Town of Medway  
**DESIGN REVIEW COMMITTEE**  
155 Village Street, Medway MA 02053  
(508) 533-3291

**DRC Meeting Minutes: January 08, 2018**  
Medway Public Library (Conference Room)

**Sign Design Review – O’ Reilly’s Auto Parts- 106 Main Street:** (See attached)

**DRC Sign Design Review**  
**Planning and Economic Development Office Comments**  
**January 5, 2018**

## Formed Cloud Logo with "AP" Formed Caps & Channel Returns

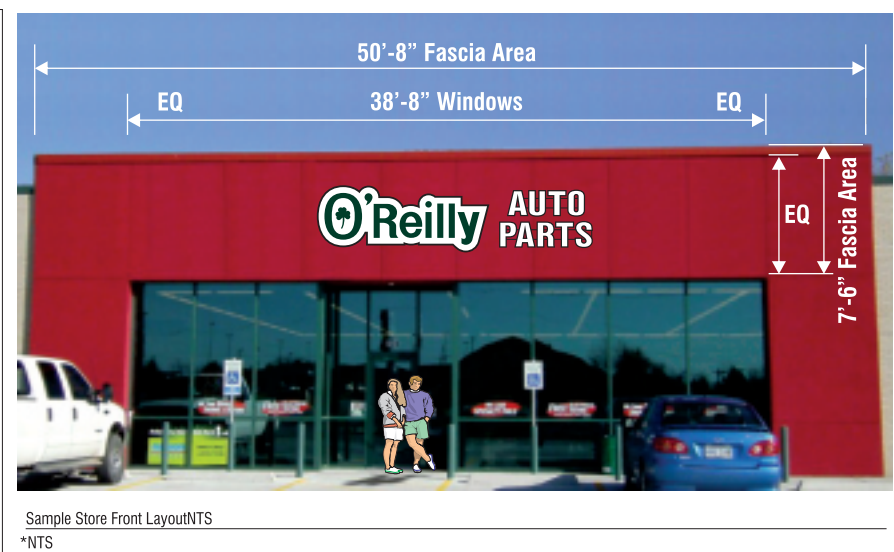
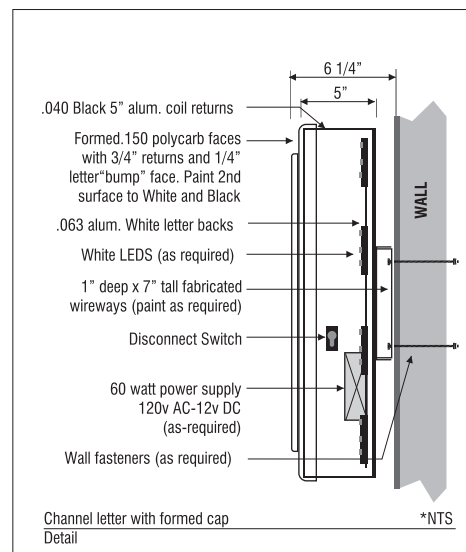
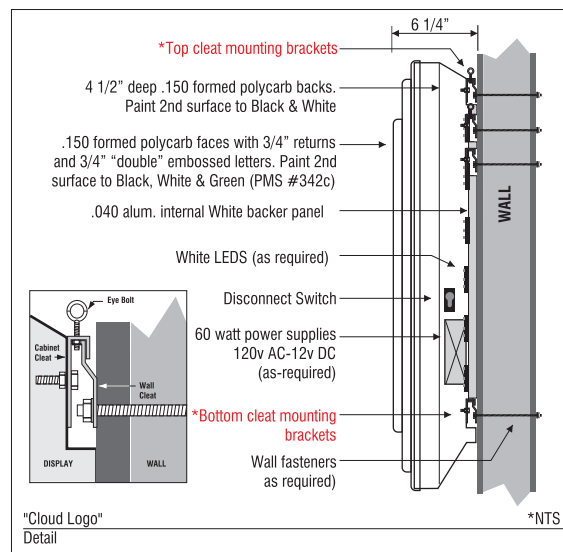
- ❖ There was a question whether it would have a raceway or be flush mounted. Response was it will have a raceway behind the sign. O'Reilly's is one word without any rectangle/ silhouette around it.

- ❖ Ms. Chabot asked if internal illumination in the sign is allowed and the response is yes. The entire sign will be illuminated with LED's.
- ❖ One of the DRC's recommendations will be that the internal illumination should be turned off after the business hours. Lighting hours should comply with the by-law.

- ❖ Mr. Buckley asked if the specs sign could just have the word O'Reilly's. Response was that "Auto Parts" should also be part of the sign.
- ❖ There was some discussion on the plaza monument sign on the street. Representative said the plaza landlord is responsible for the installation of the signs on the monument.

1. New business. Location is where Dollar Tree used to be.
2. Width of business storefront = 60' estimate per the application. Sign fabricator, Russ Baker, will check on this on Monday. If the storefront width is 60', then only 60 sq. ft. of sign surface area is permitted and this sign is too big as proposed.

**NOTE** – The Medway Building Department indicates that the storefront width is 70.3 linear feet based on current building permit plans on file. Accordingly, the proposed 68.56 sq. ft. of sign surface area is OK.

**1 PROPOSED FRONT (SOUTH) ELEVATION**  
A2.1 SCALE: 1/8" = 1'-0"

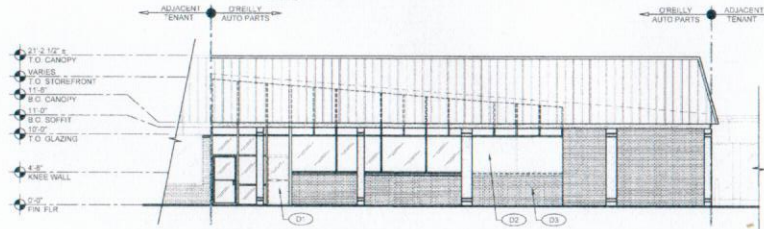
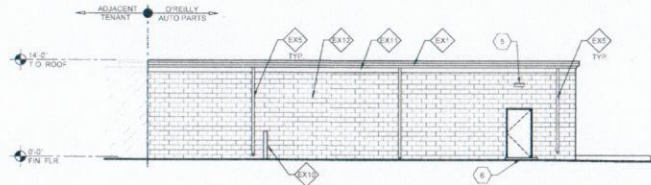
- ❖ Mr. Buckley said façade in this location has silhouettes from the signs of the previous two tenants. DRC has been recommending to the new tenants that they paint out the silhouettes. Mr. Buckley said this will be one of the DRC's recommendations to the Building Department before the permit is issued. Representative said he will convey this requirement to the applicant.

3. Discuss removal of any shadowing on the façade left behind from previous signs.
